AGENDA
Design Review Committee
November 8, 2023 – REGULAR MEETING

Town of Jackson Design Guidelines Checklist

Item Number: P23-175

Response to Town of Jackson DRC Comments dated 2023 September 26

WEST BUILDING - PREVIOUS APPROVED DRC RENDERING

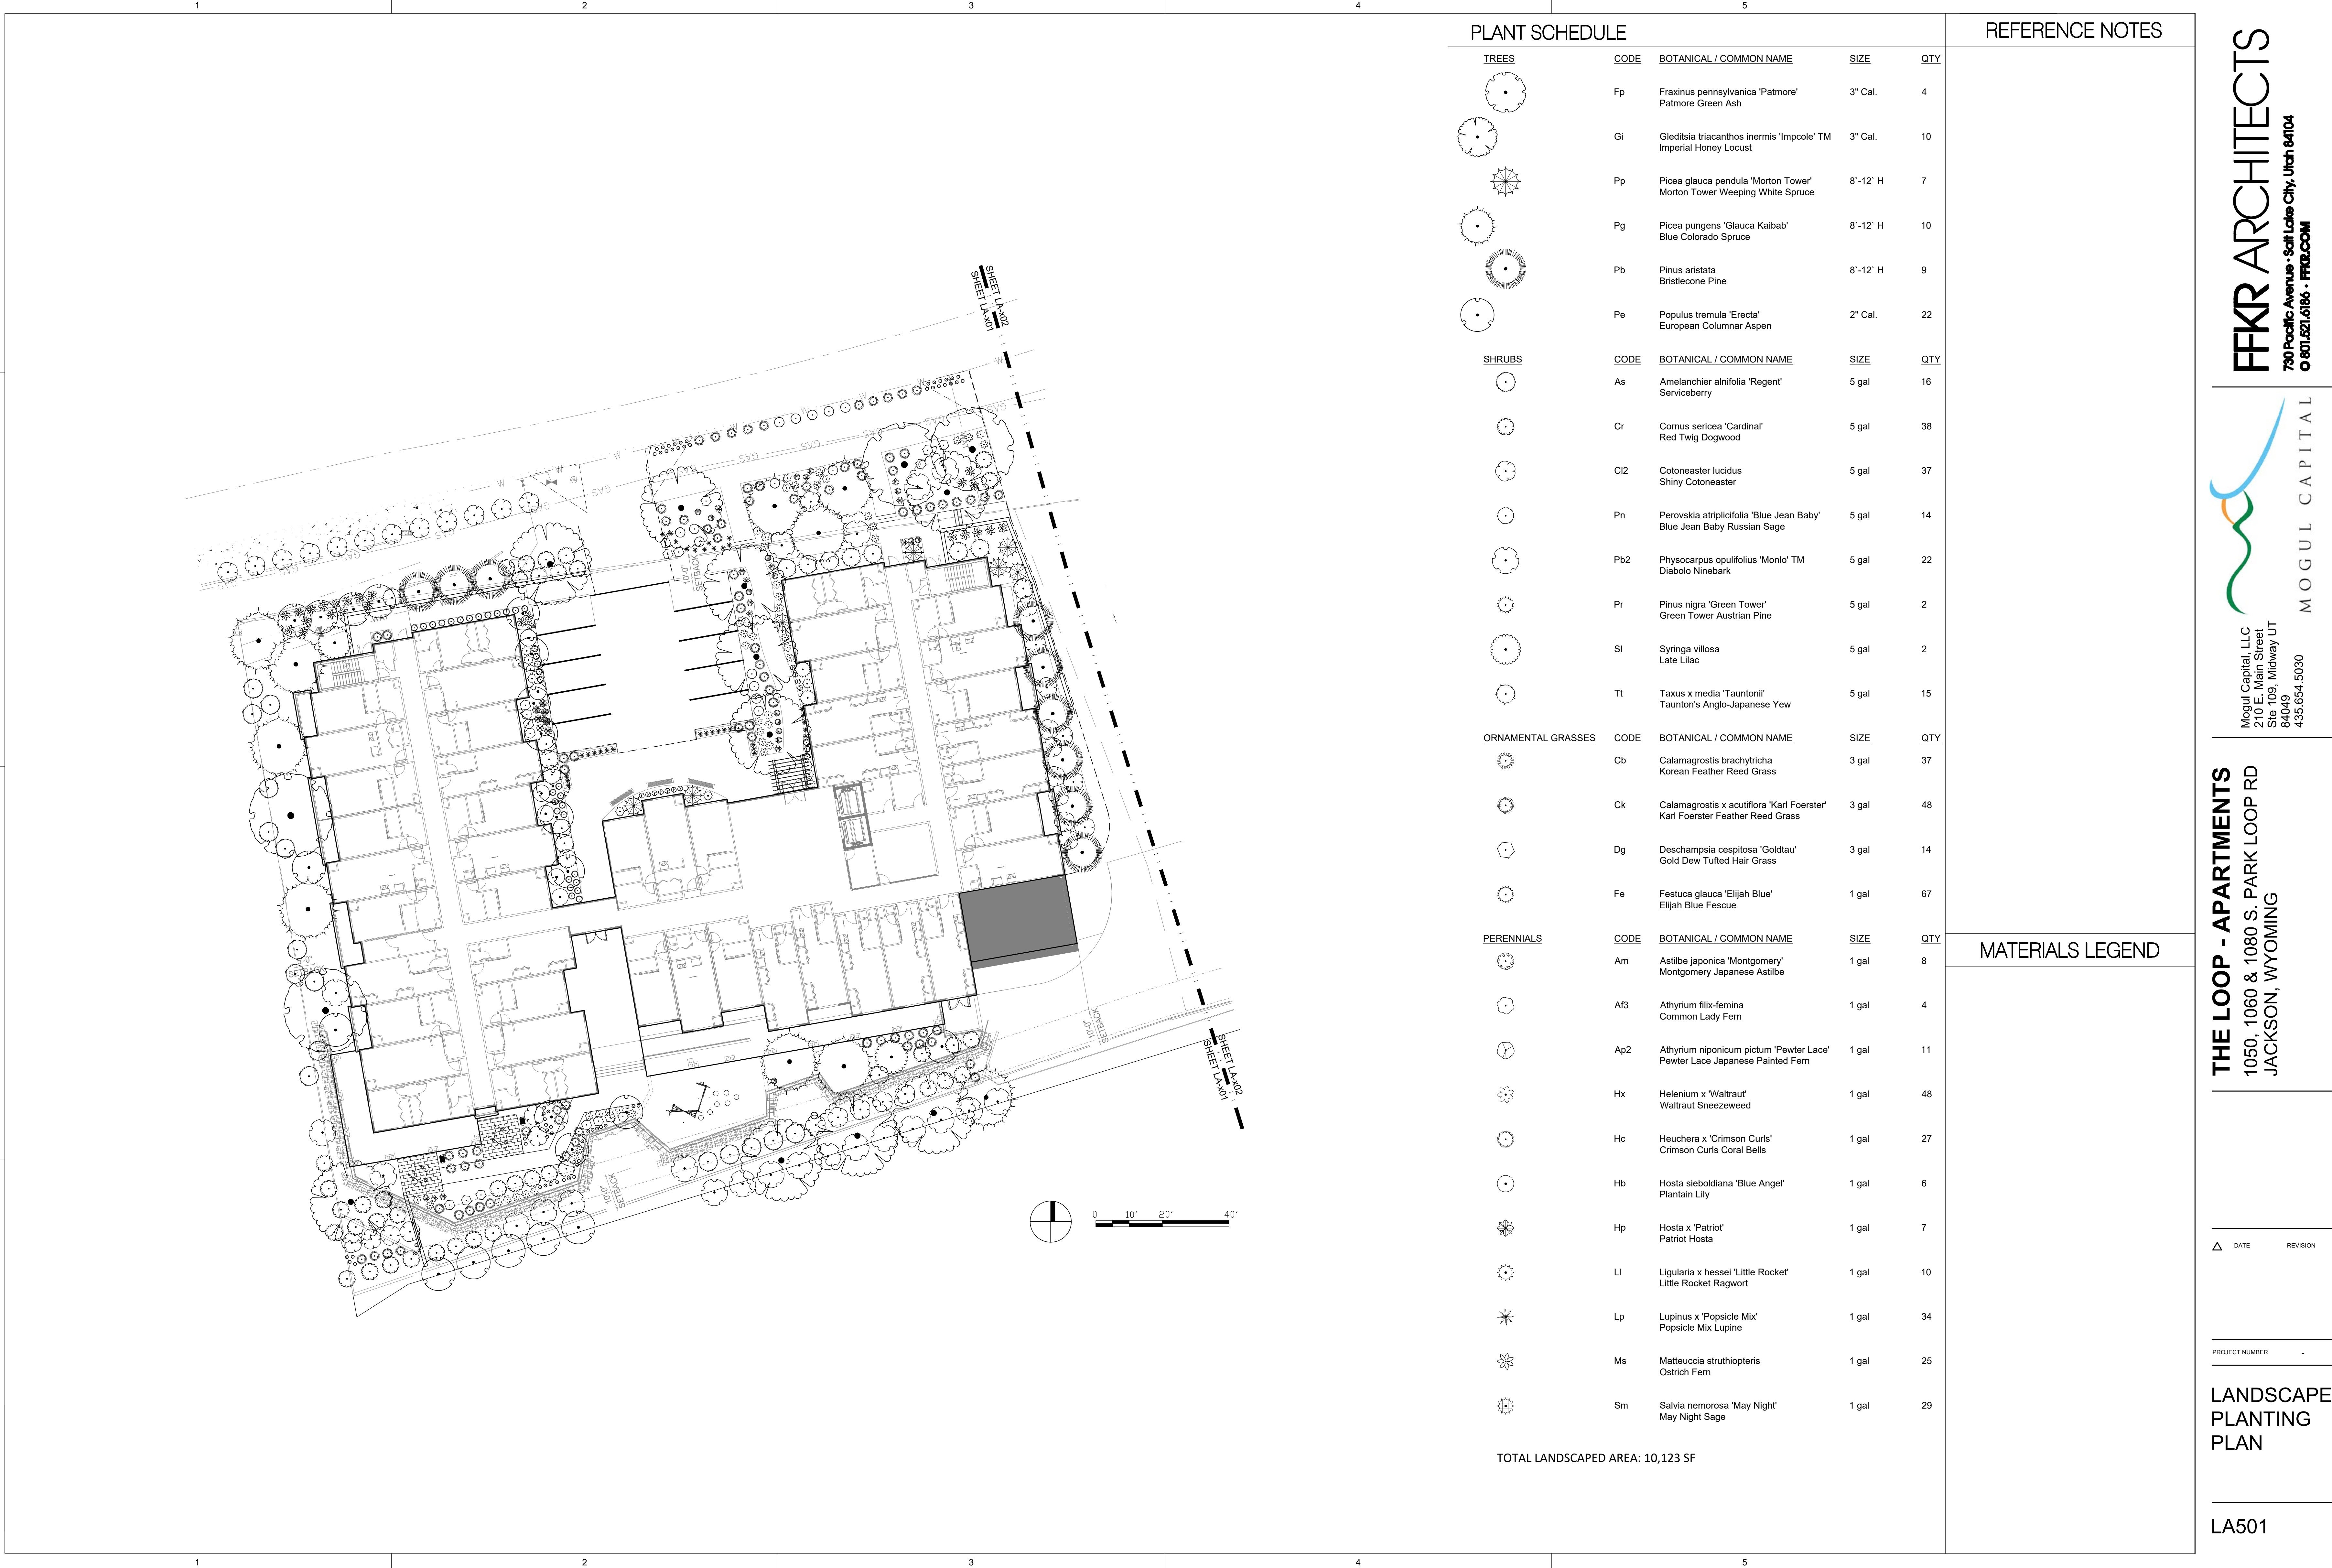
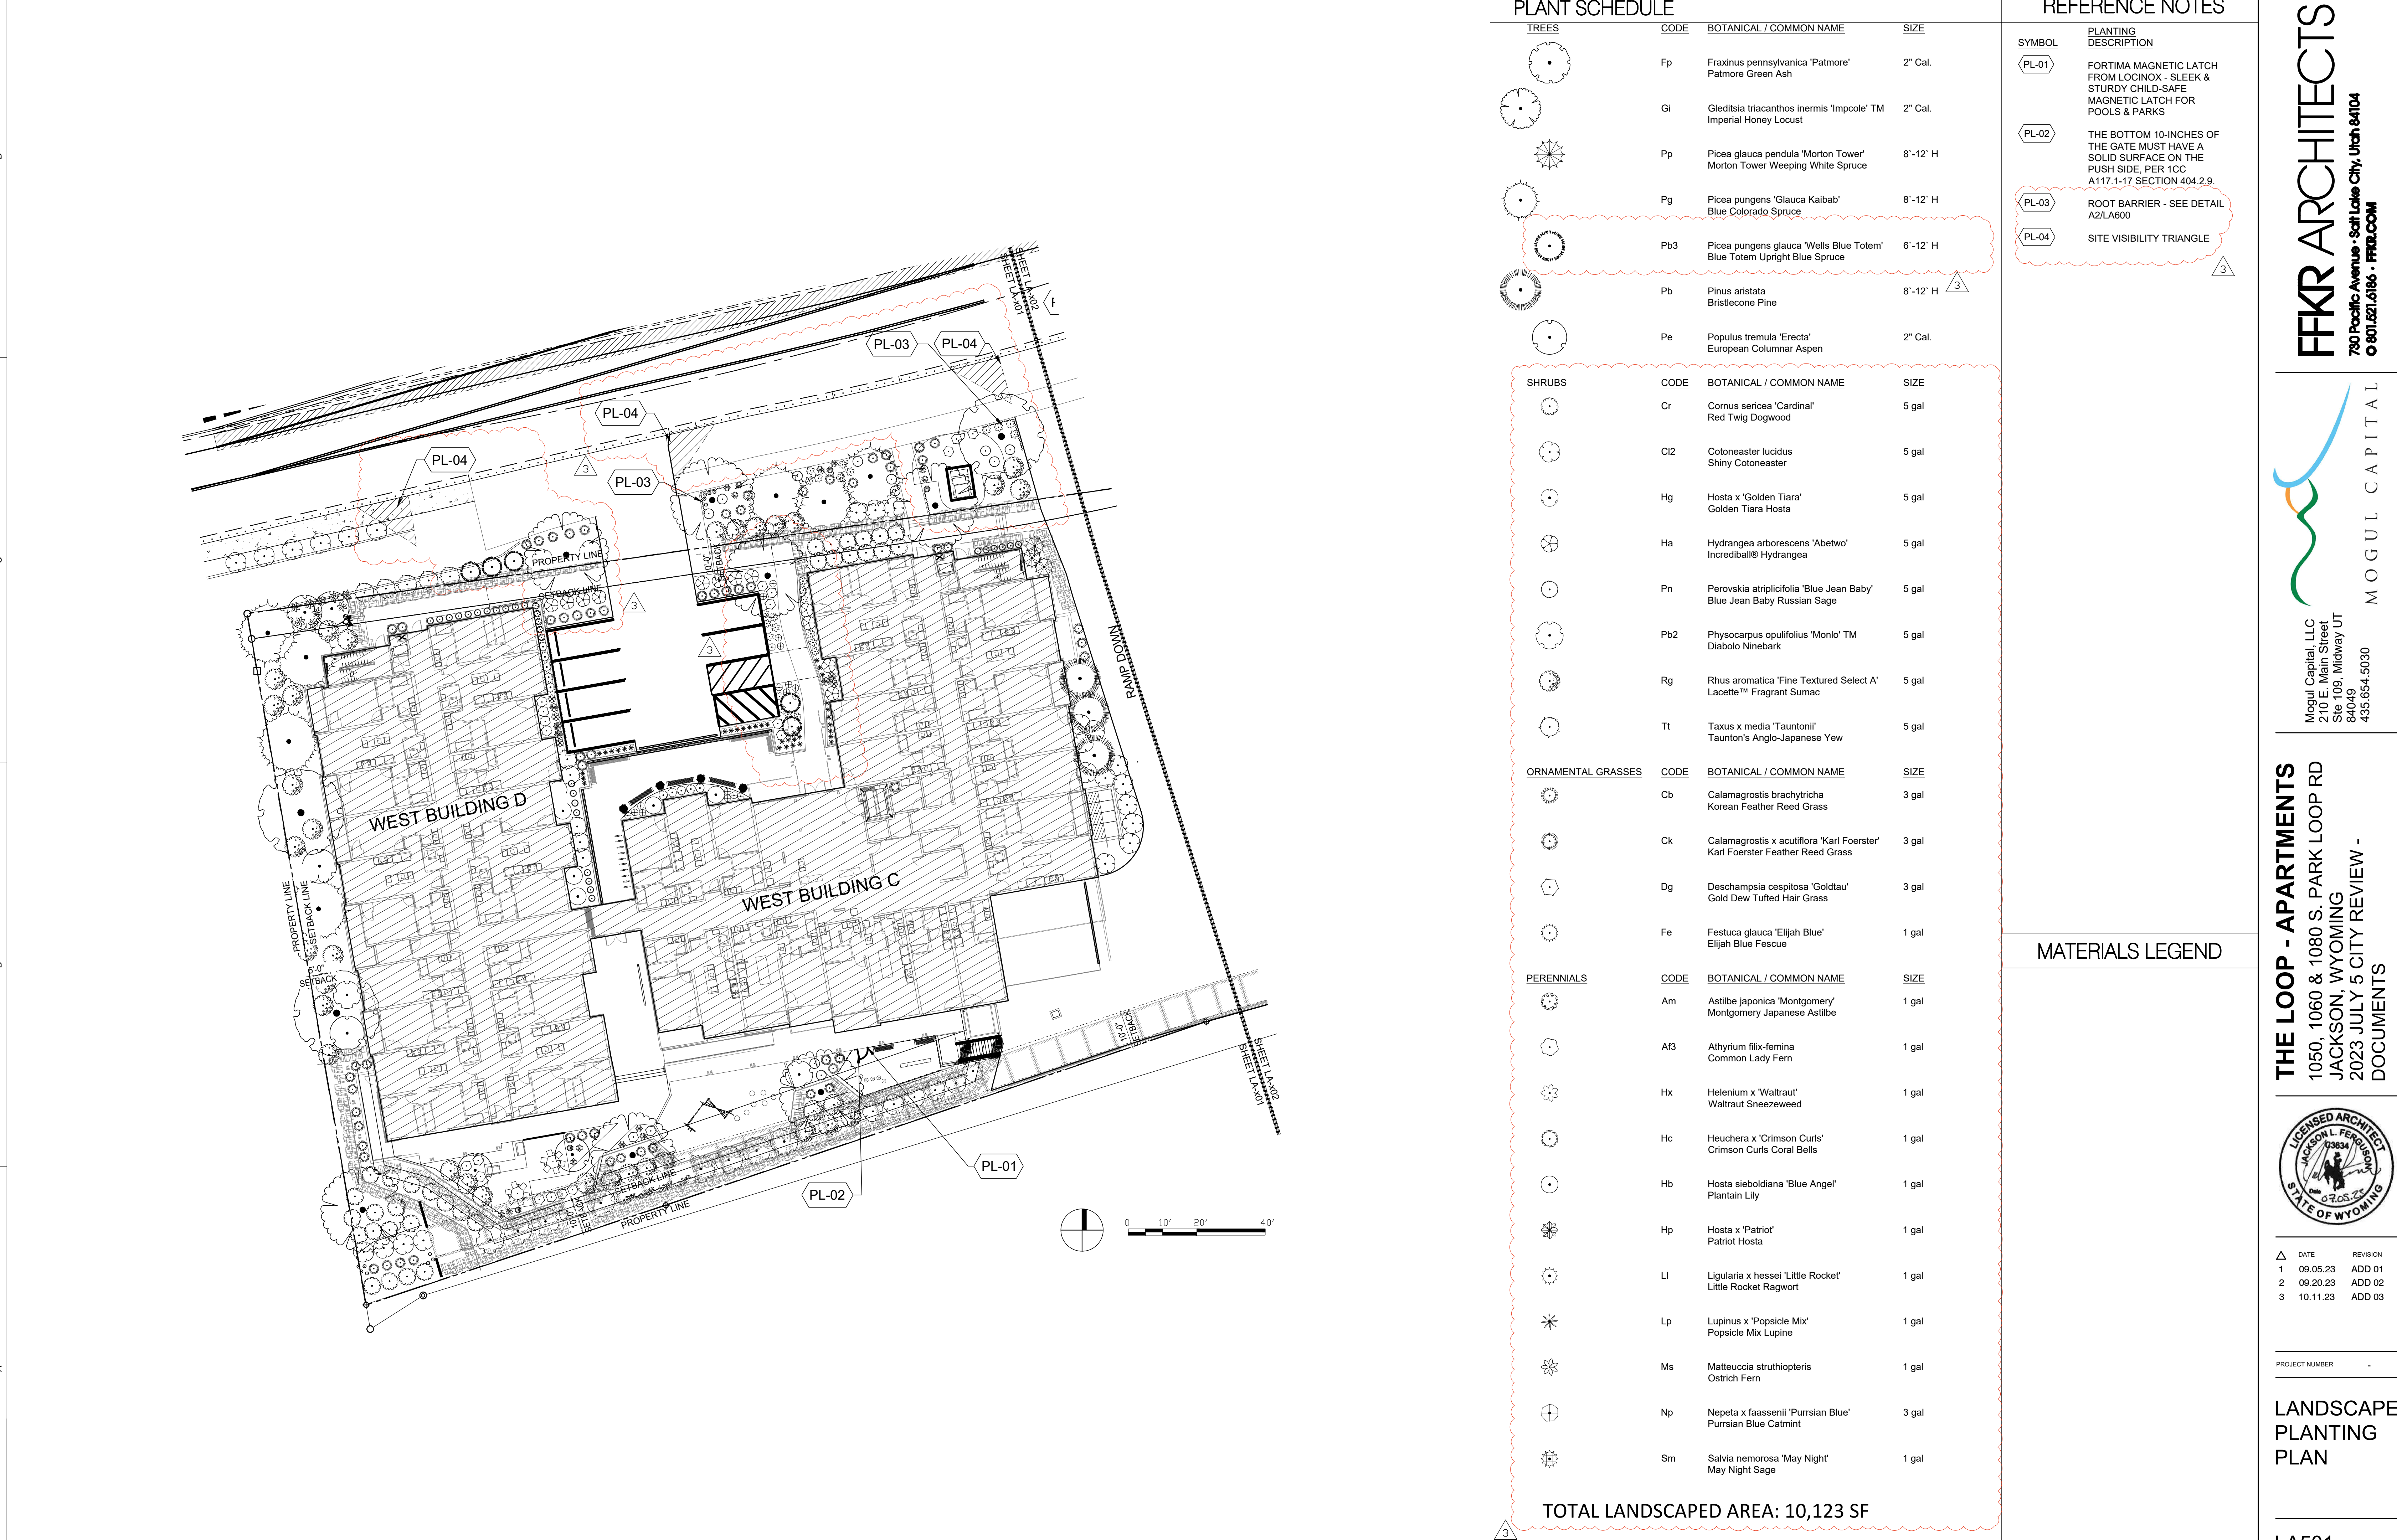
Staff note – The applicant is proposing changes to the approved courtyard landscape plan. The major difference is that there appear to be +/-10 fewer trees in the west courtyard and 2 fewer trees in the east courtyard. In general, the number of shrubs and perennials in both courtyards is comparable.

In addition, there's been some unintentional misinformation regarding the amount of approved sod. In the approved plan below, and all approved 3D renderings, the green areas represented sod and designated areas for planting trees, shrubs, and perennials. However, the applicant has stated that their intent all along was to have rock mulch instead of sod based on the high quantity of ground-covering shrubs and perennials. Mulch is a permitted landscape material, however, the Town does not allow mulch as the primary landscape material. Based on the approved plans, the Town is expecting sod to be placed throughout the site but would allow mulch in certain areas, especially areas with dense shrubs and perennials. Staff is seeking the DRC's feedback on this topic.

C2 TYPICAL GUARDRAIL SECTION
SCALE: 1 1/2" = 1'-0"

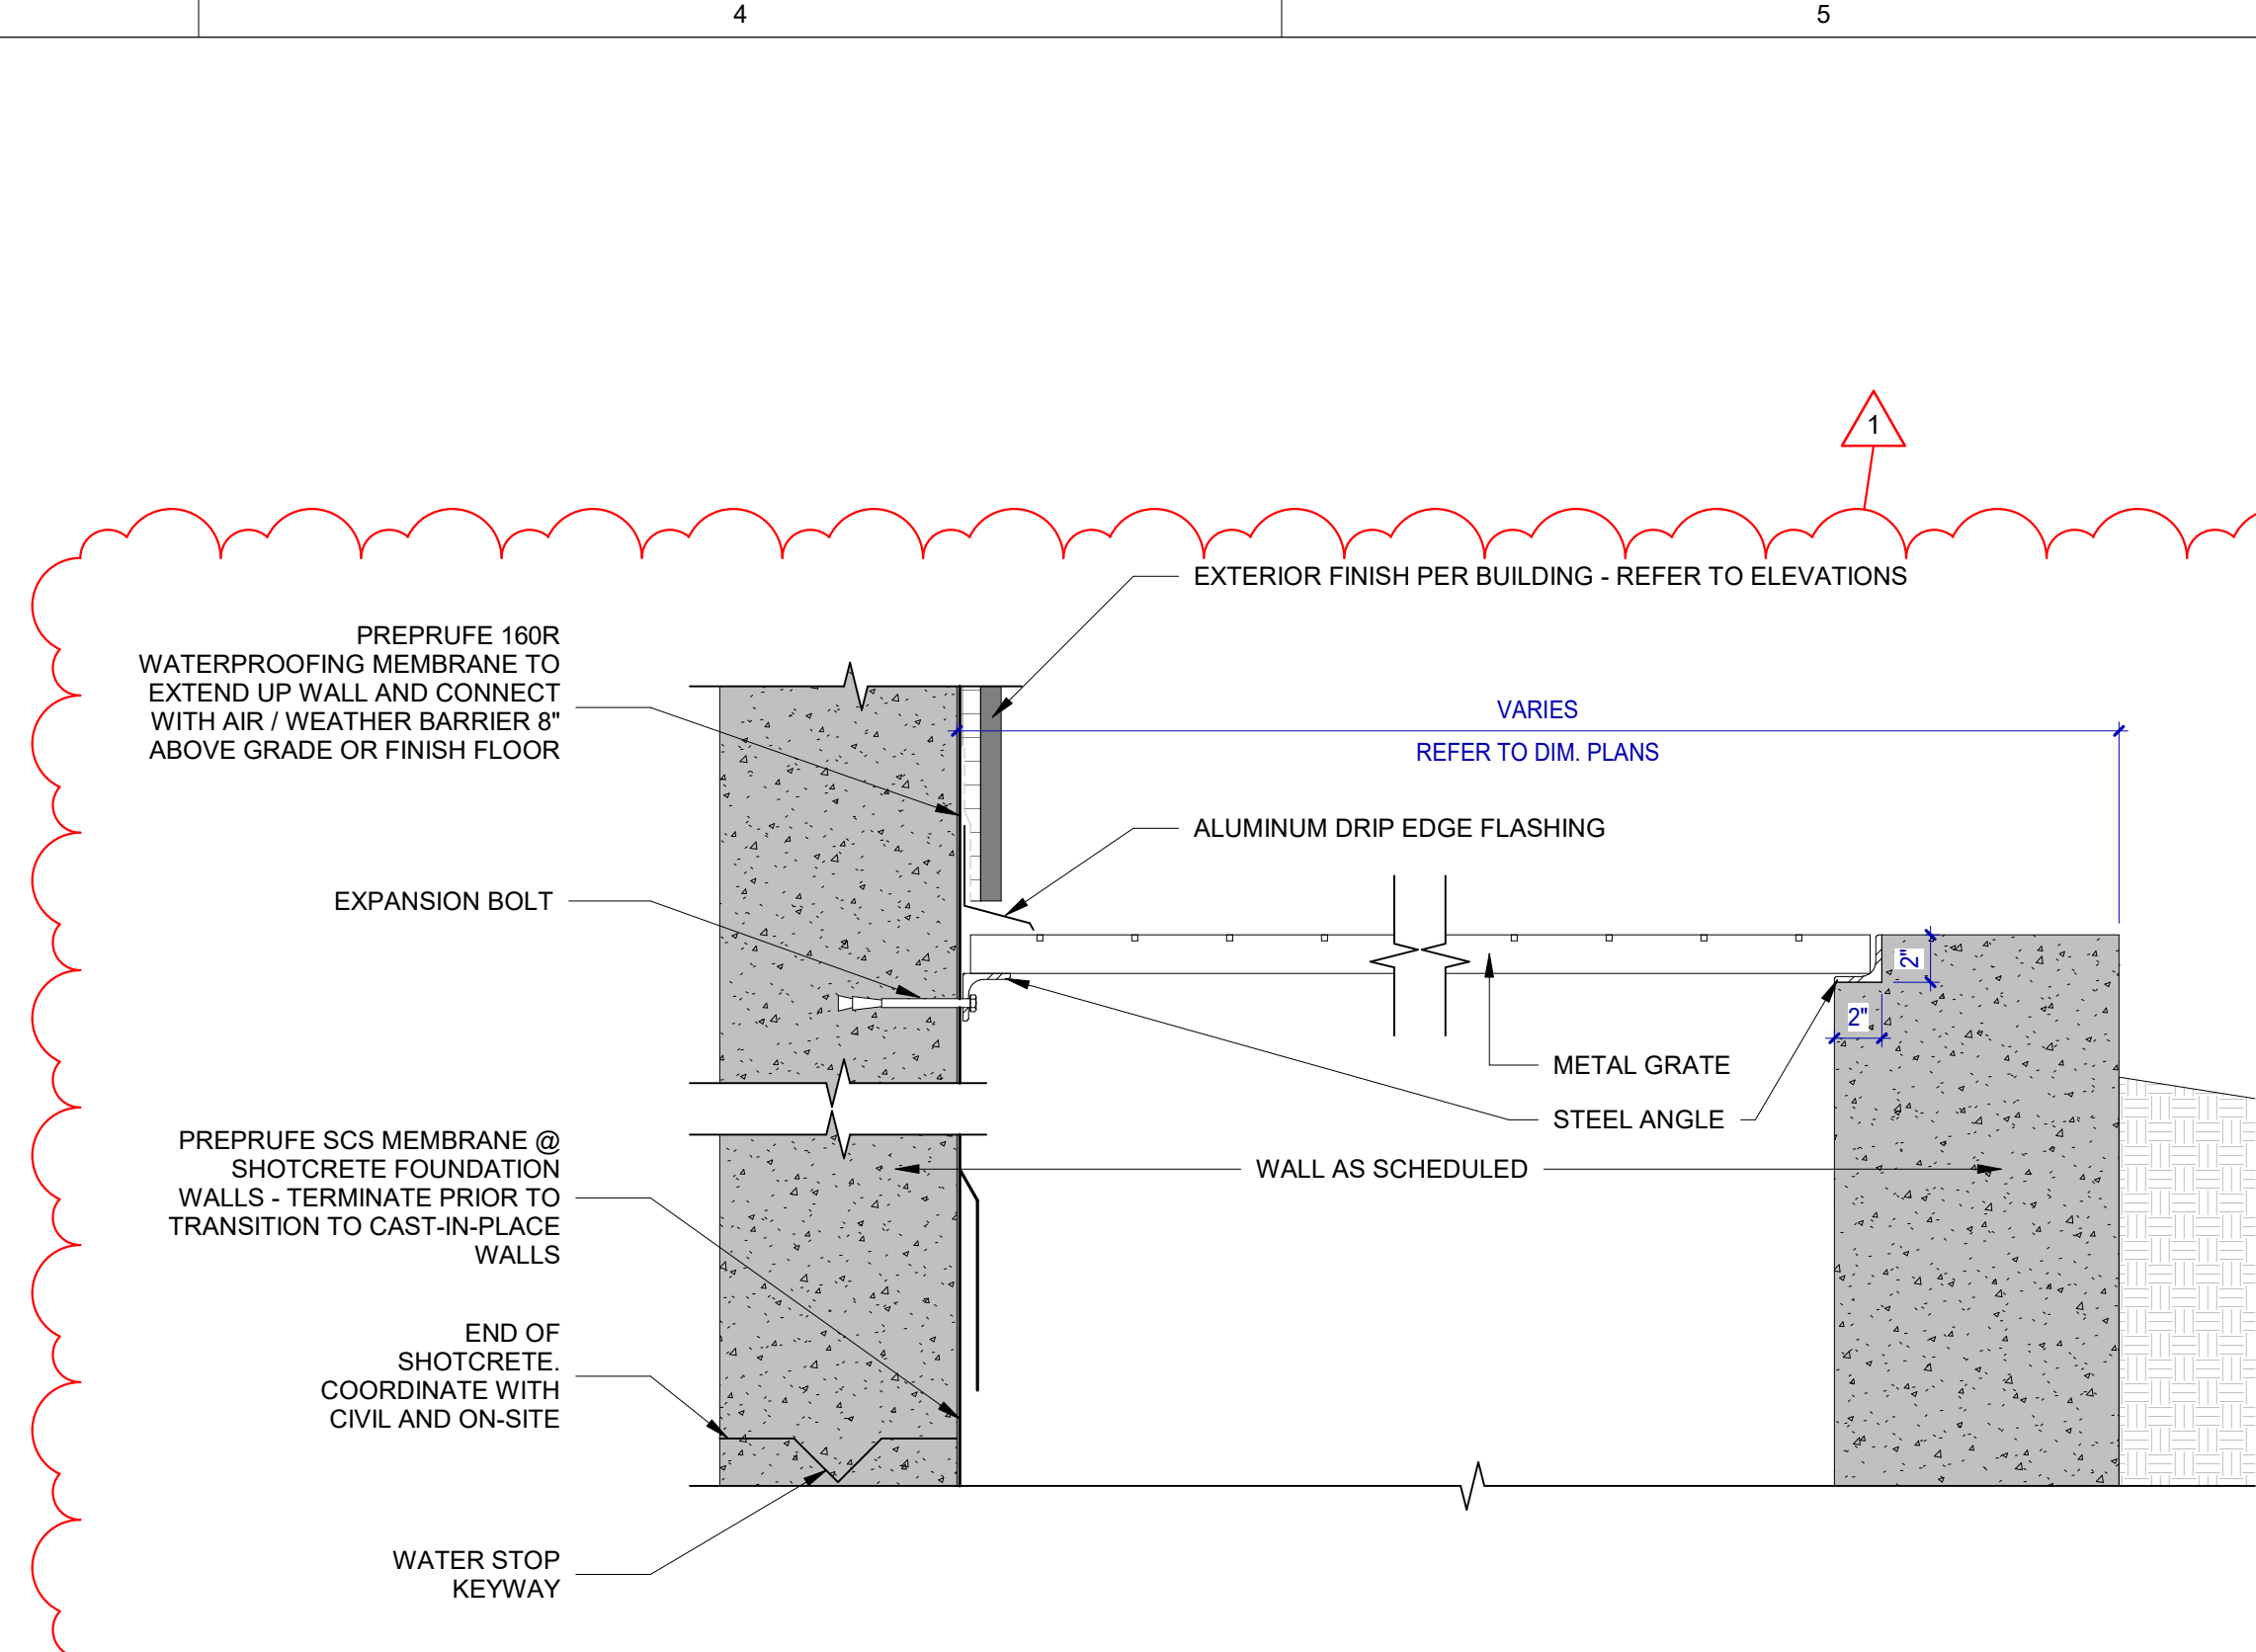
- c. Provide more details on the guardrails along the rear of the property.

Response: Guardrail details have been provided on sheet A501.

- Provide more details on the guardrails along the rear of the property. **See details A2 & C2 on sheet A501. Also, see the attached guardrail/ boulder wall exhibit.**
